ADDENDUM NUMBER: Two (2)

TITLE: Vendor Services Payment Kiosk Lease or Purchase and Maintenance Program

JEA ITN NUMBER: 98130

Kiosk Pillar Right:

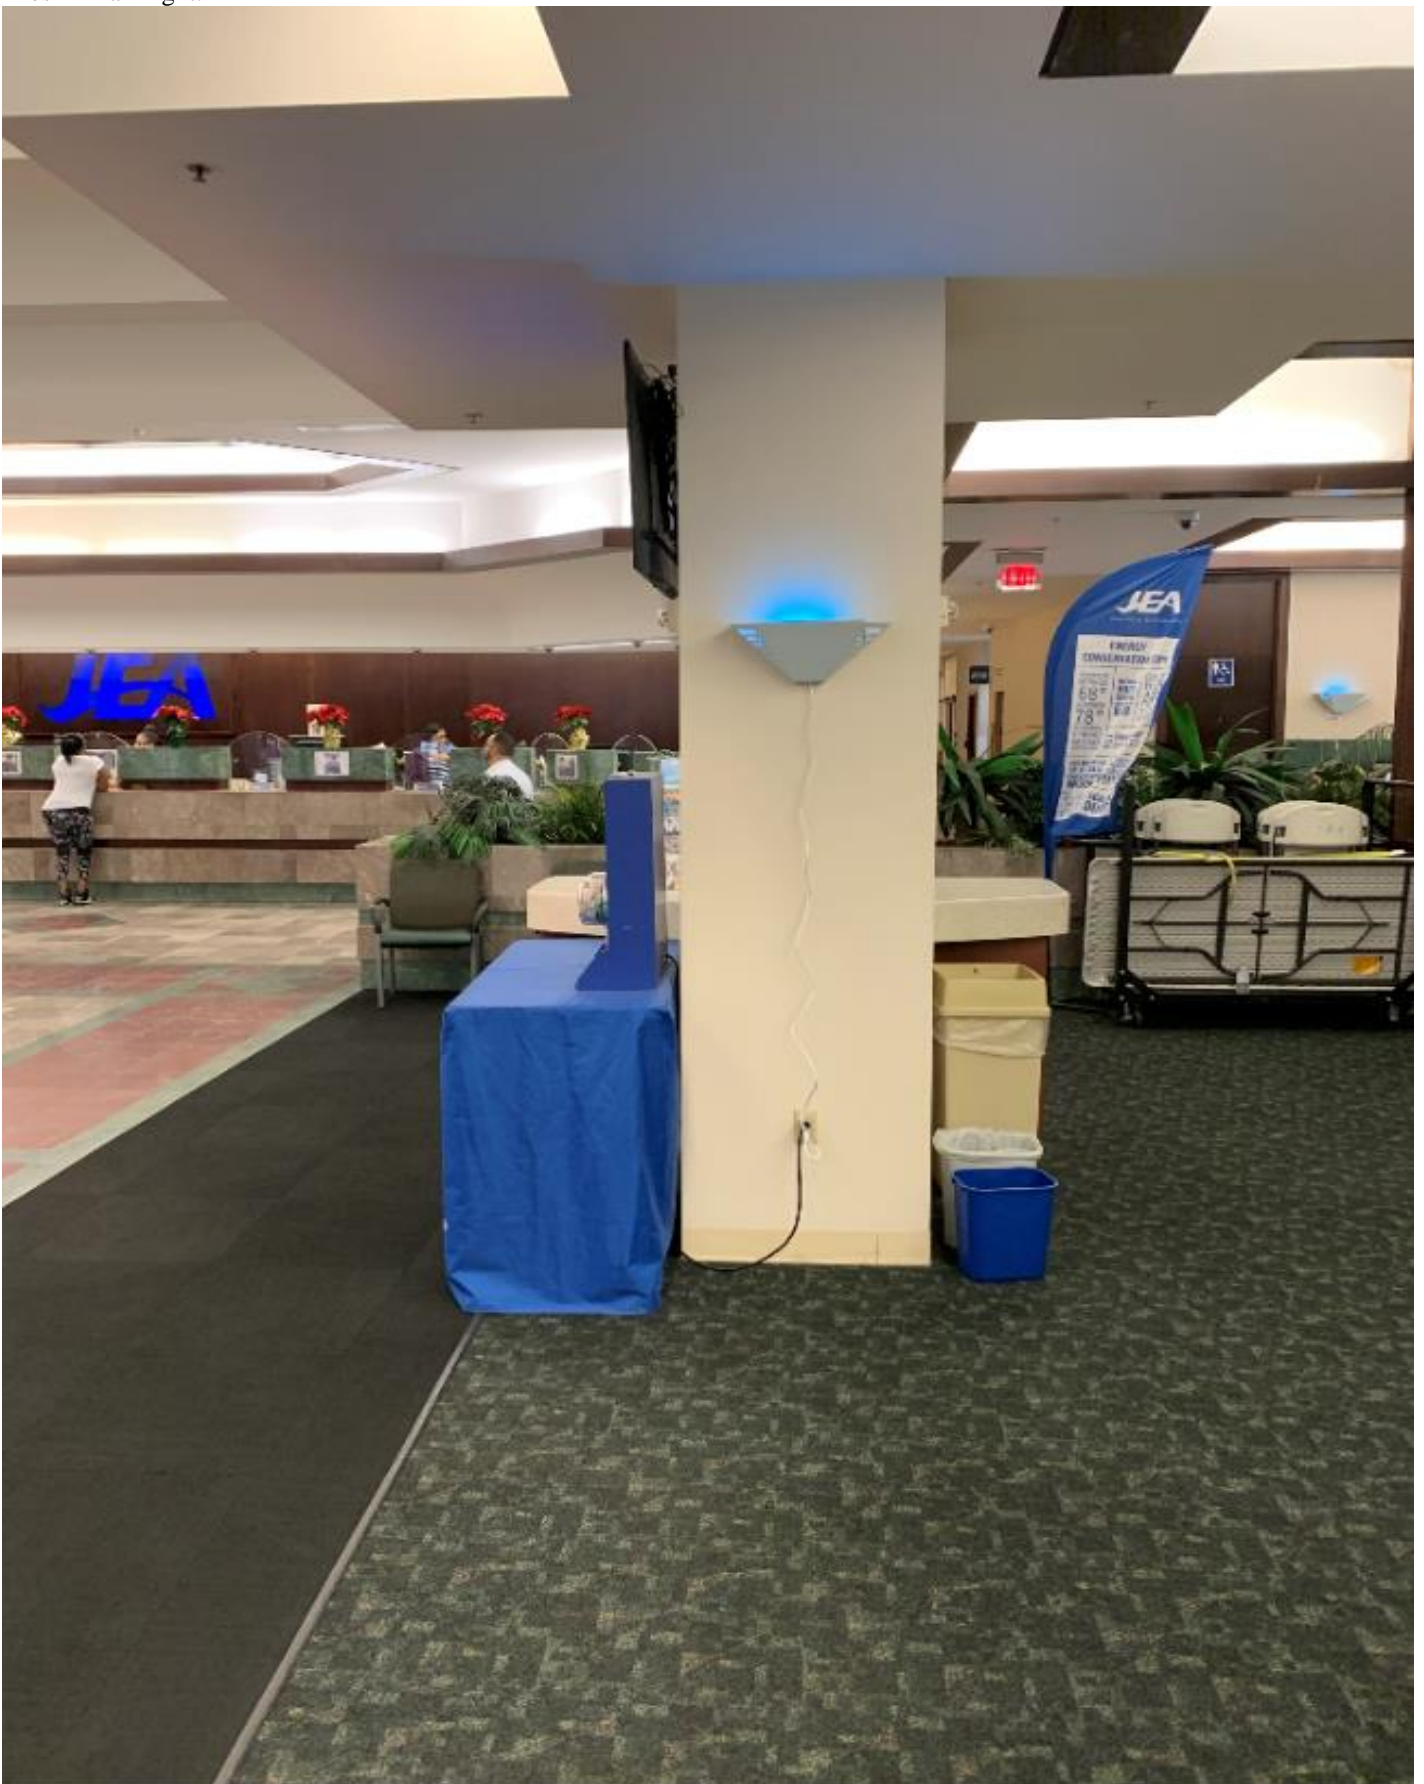
2. What are the room dimensions and proposed hardware location(s)?

2. Room is "cavernous". Proposing that the kiosk machines be placed beside two opposing pillars on either side of the room, or on adjoining sides of one pillar on one side of the room. Floor is carpeted.
